U.S. Department of the Interior BUREAU OF LAND MANAGEMENT Sundry Print Report

#### **Notice of Intent**

Type of Action: Plug and Abandonment

# Apache 127 #124

### Proposed P&A

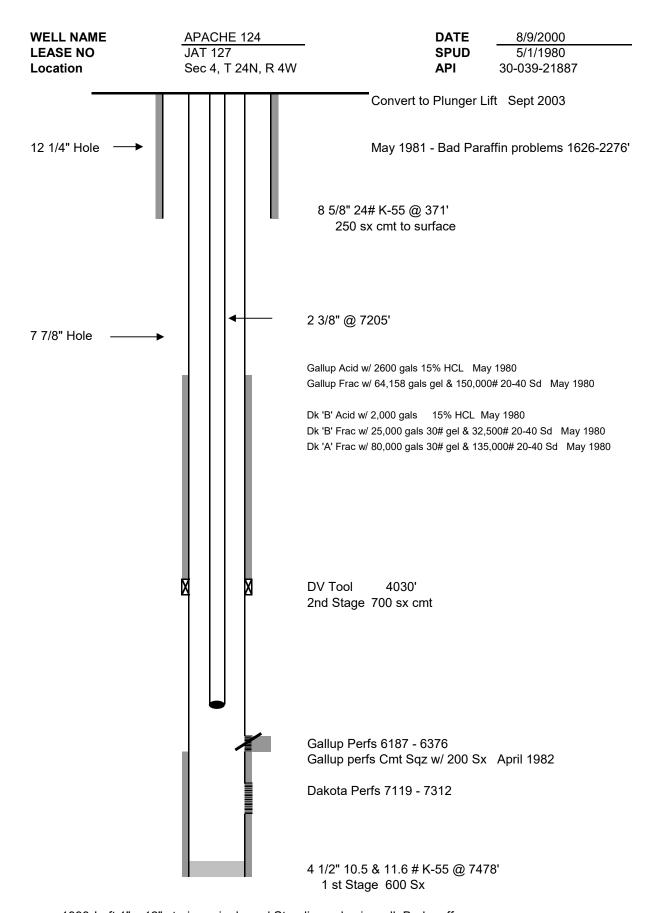
-Many of the plugs must be modified to cover the BLM formation depths:

The Plug 2 TOC must be extended to 6113' and the base extended down to 6263' to account for a moved top and required excess.

The Plug 3 TOC must be extended to 5155' and the base extended down to 5305' to account for a moved top and required excess.

The Plug 4 TOC must be extended to 4450' and the base extended down to 4600' to account for a moved top and required excess.

The Plug 5 TOC should be extended to 3660' and the base extended down to 3810' to account for a moved top and excess cement.

The Plug 7 TOC must be extended to 610' and the base extended down to 760' to account for a moved top and required excess.

- Plug 2: TOC must be extended to 6113 feet and the base extended down to 6263 feet to account for a moved top and required excess.
  - b) Plug 3: TOC must be extended to 5155 feet and the base extended down to 5305 feet to account for a moved top and required excess.

- c) Plug 4: TOC must be extended to 4450 feet and the base extended down to 4600 feet to account for a moved top and required excess.
  - d) Plug 5: TOC should be extended to 3660 feet and the base extended down to 3810 feet to account for a moved top and excess cement.

- e) Plug 7: TOC must be extended to 610 feet and the base extended down to 760 feet to account for a moved top and required excess.
- 3. Farmington Office is to be notified at least 24 hours before the plugging operations commence (505) 564-7750.
